Please find attached a submission objecting to REV2022/0004 for a childcare centre at 16 Bangaroo Street North Balgowlah on behalf of residents.

RE: REV2022/0004 16 Bangaroo Street North Balgowlah

Figure 1: Required acoustic barriers as outlined in Acoustic Report by Wilkinson Murray

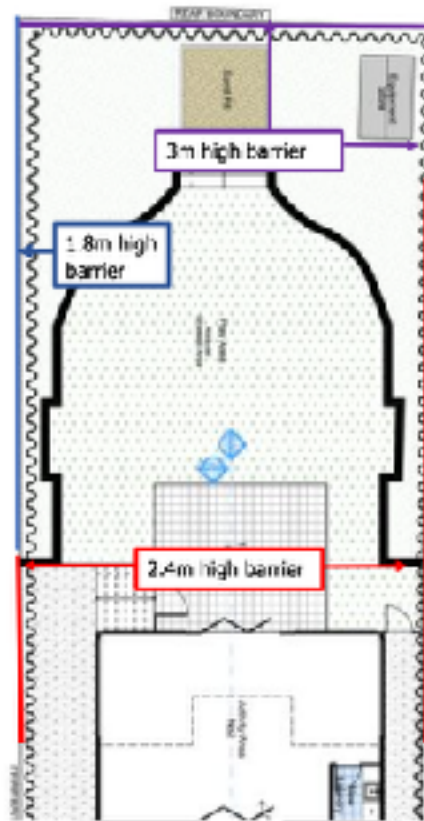
Barriers on the boundary that require a height of more than 1.8m are not considered to be consistent with predominant side boundary fencing of low density residential areas. As shown in Figure 1 below, fences with heights of 2.4 - 3.0m on the boundary as proposed will result in significant adverse visual amenity impacts for neighbours. Creating high boundary walls is not an acceptable response to the visual characteristics of the site or qualities of the surrounding neighbourhood and demonstrates the unsuitability of a site with low background noise levels to a childcare centre.

The materials proposed for the walls have not been nominated and given the acoustic properties needed, it is likely their solidity and height will exacerbate their adverse visual impact.

In addition, walls up to 3m high will cast additional shadow on neighbouring residential properties. This impact has not been identified and diagrams demonstrating the extent of that impact should be submitted to allow the impacts to be properly assessed.
